Date / Datum / Date / Fecha / Dato December 1979

CONC. REMOTE CONTROL H1200

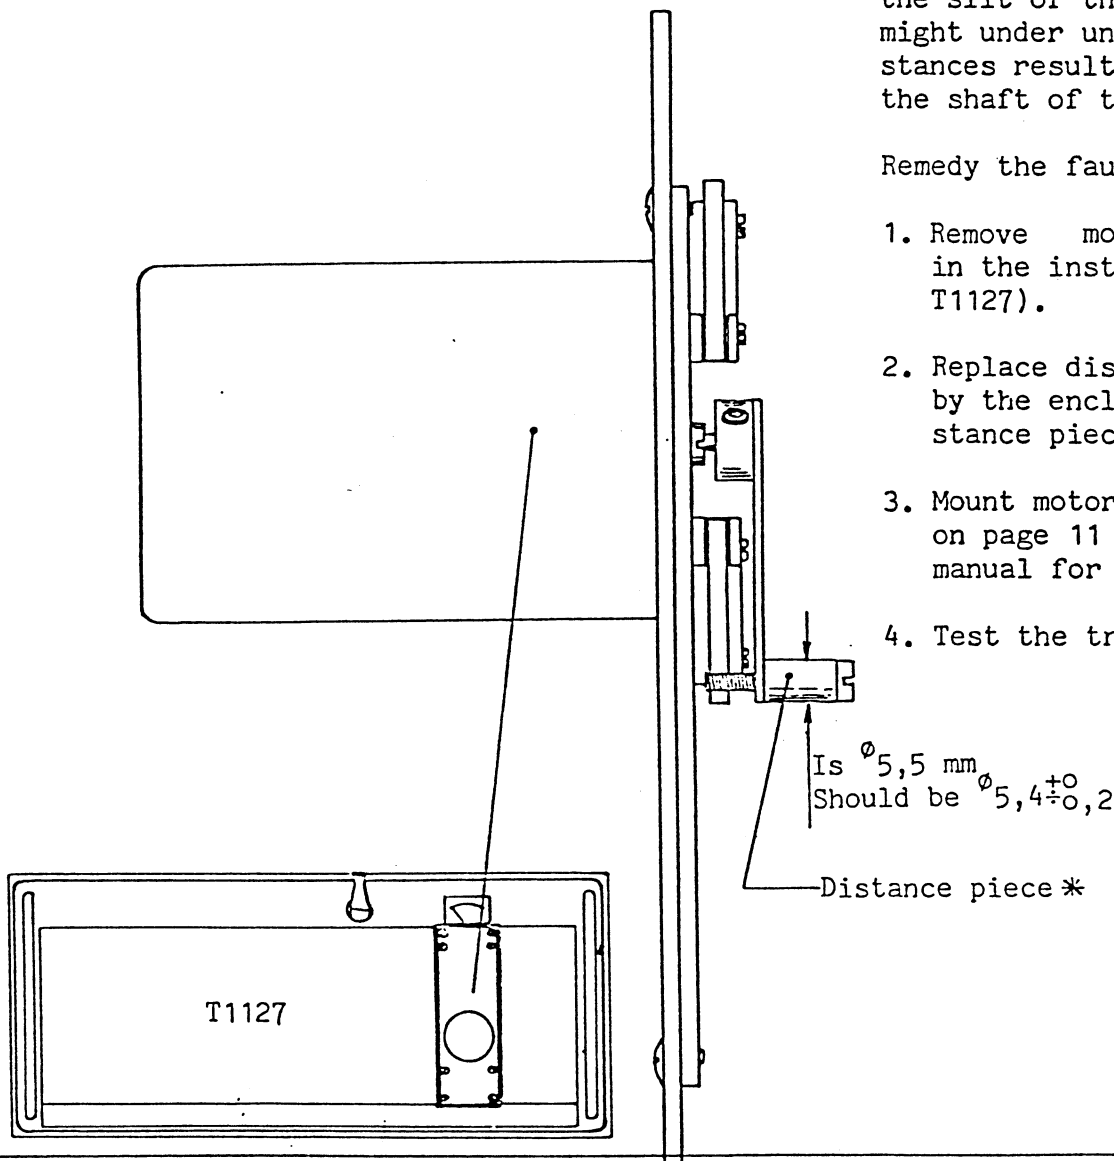
Much to our regret it has turned out that some of these units have been delivered with a fault that has not been detected by our final control.

The fault is that the distance piece marked * on the drawing has been manufactured with an outside diameter of 5.5 mm instead of $\phi 5.4^{+0}_{-0.2}$ mm, which is correct.

The effect is that the distance piece is working very tightly in the slit of the TUNE shaft, which might under unfortunate circumstances result in an overload of the shaft of the motor.

Remedy the fault as follows:

1. Remove motor (see page 11 in the instruction manual for T1127).
2. Replace distance piece marked * by the enclosed correct distance piece.
3. Mount motor unit as described on page 11 in the instruction manual for T1127.
4. Test the transmitter.
